Comments of AMO, DEVB

雨水排放建議圖

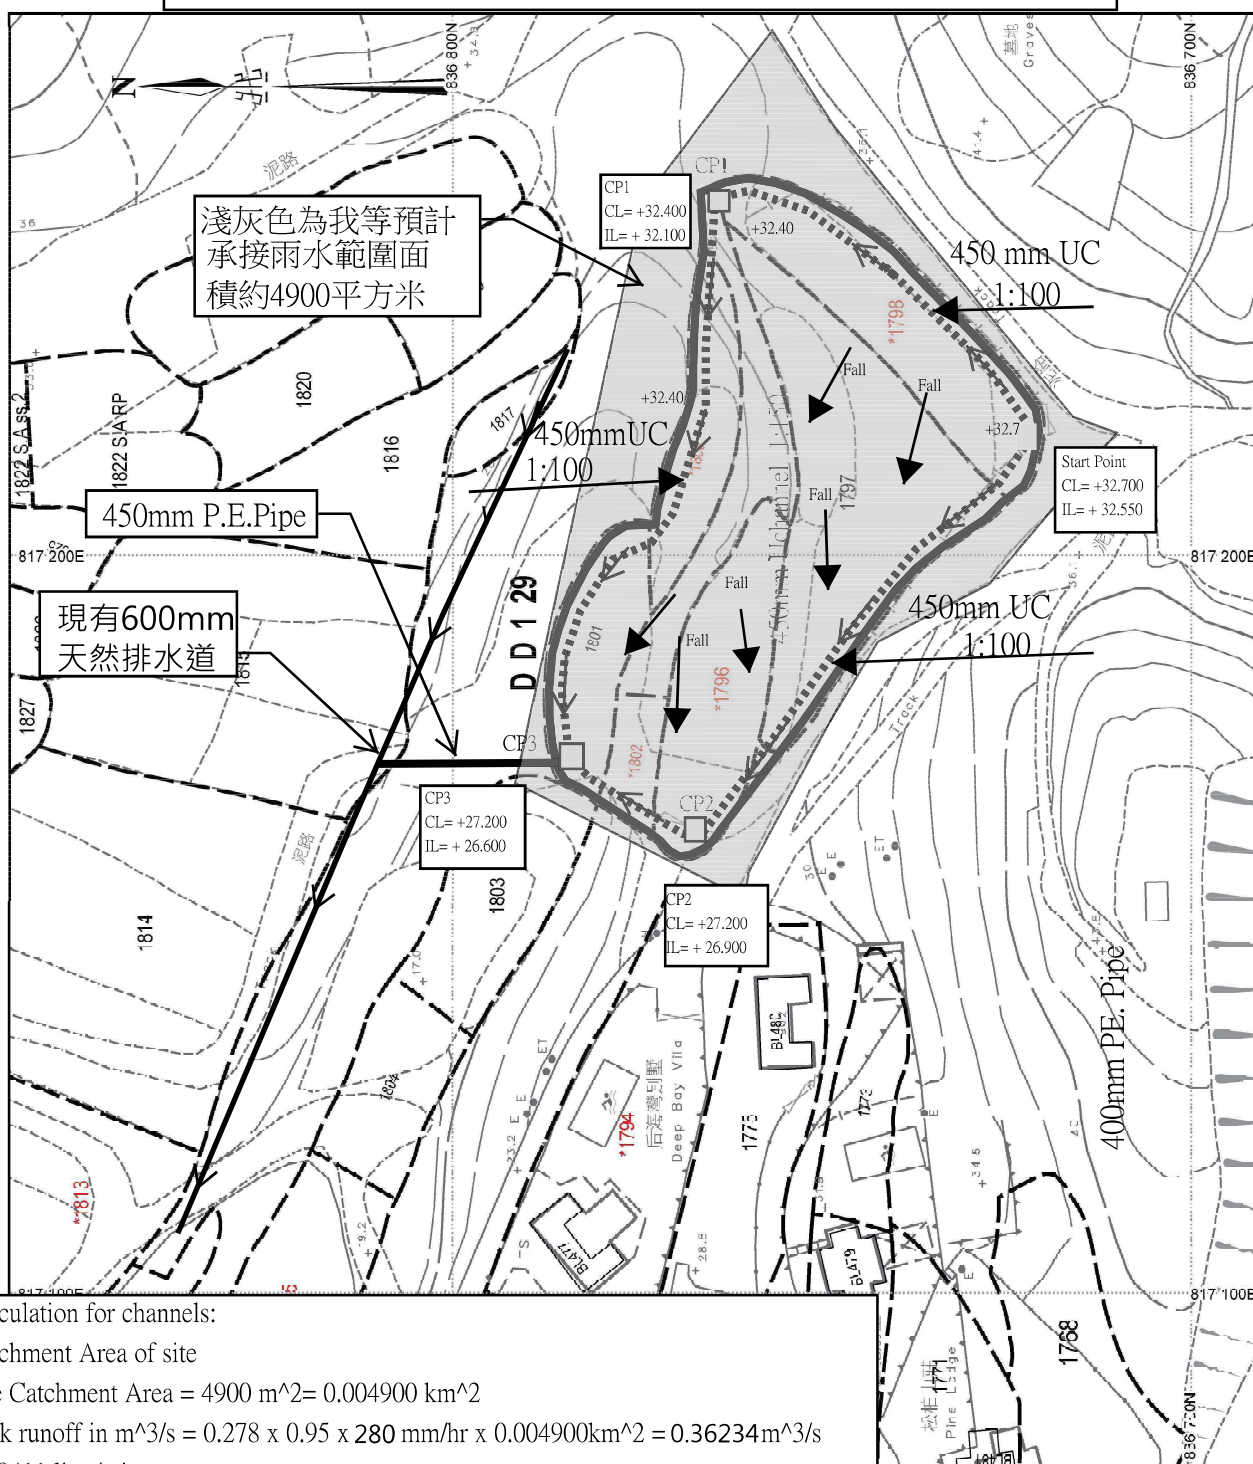
As the application site is situated within the Lau Fau Shan Site of Archaeological Interest, the applicant is required to confirm / clarify with the Antiquities and Monuments Office (AMO) whether there is any ground excavation proposed for the development including but not limited to site formation works, drainage works, sewerage works, construction of septic tank etc. If affirmative, the applicant is required to provide details of the proposed works, e.g. the location, extent and depth of the proposed ground excavation for AMO's further comment.

1. 如獲得批准，我等的臨建築物全部以臨時物料搭建，及只有 1 層高，因此不須要建造地基 因此我等不會進行挖掘泥土的工序，平整地盤及地基工程。
2. 如獲批准我等會進行排水工程，將會在申請範圍的周邊建設排水渠，而有關排水渠的深度 約為 0.15 米至 0.6 米以內，跟據地基波幅計算，挖掘的深度不會超過 0.6 米，渠面闊度約為 0.45 米 (請看附件雨水排放建議圖)
